**Amendments to the Drawings**

The following remarks are submitted in response to the non-final Office Action mailed August 7, 2006, setting a three-month shortened statutory period for response ending November 7, 2006. With this Amendment, claims 20, 34, and 38-40 have been amended. Claims 20-40 remain pending in the Application. Reconsideration, examination and allowance of all pending claims are respectfully requested.

Application Serial No. 10/615,652  
ANNOTATED DRAWING

FIG. 8

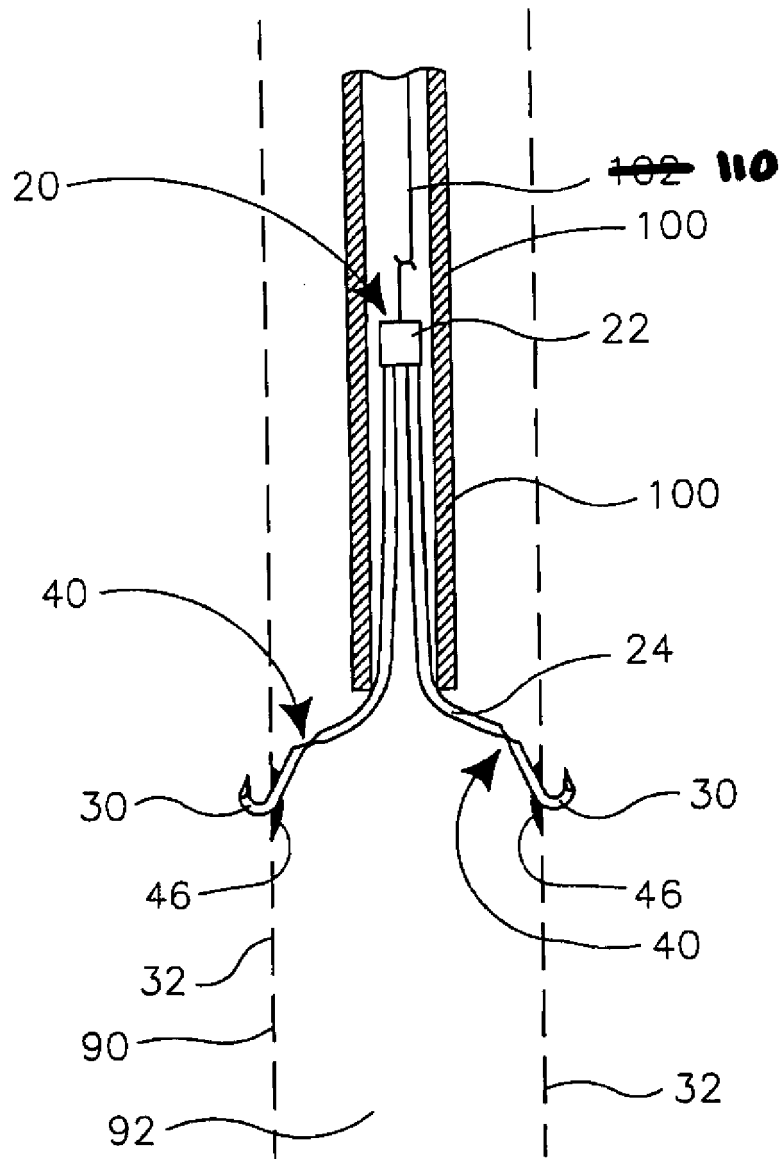
In paragraph 11 of the Office Action, the Examiner objected to the drawings under 37 CFR § 1.84(p)(5) stating that they do not include certain reference signs contained in the description. In particular, the Examiner states that, with respect to Figure 6, reference number "102" should be labeled "112" and reference number "100" should be labeled "110". In addition, with respect to Figure 8, the Examiner states that reference number "112" should be labeled "110" or some other reference numeral since "110" is used to designate the retrieval catheter (110) in Figure 6. According to the Examiner, corrected drawing sheets are required.

In paragraph 12 of the Office Action, the Examiner objected to the disclosure stating that the “force transfer member 110” mentioned on page 13, line 15 of the Application is not shown in any of the figures.

With respect to the objection of Figure 8, Applicant has replaced reference number “102” (*i.e.* the force transfer member) in that figure with reference number “110”. Support for this amendment can be found, for example, on page 13, line 15 of the Application. A “Replacement Sheet” reflecting this change is attached hereto.

With this Amendment, Applicant has amended Figure 8 by replacing reference number “102” with reference number “110”, which as discussed above, is supported by page 13, line 15 of the Application. In addition, Applicant has further amended page 13, line 15 of the specification by adding the phrase “(see Figure 8)” after the words “force transfer member 110” to more clearly indicate that the force transfer member is depicted in Figure 8.
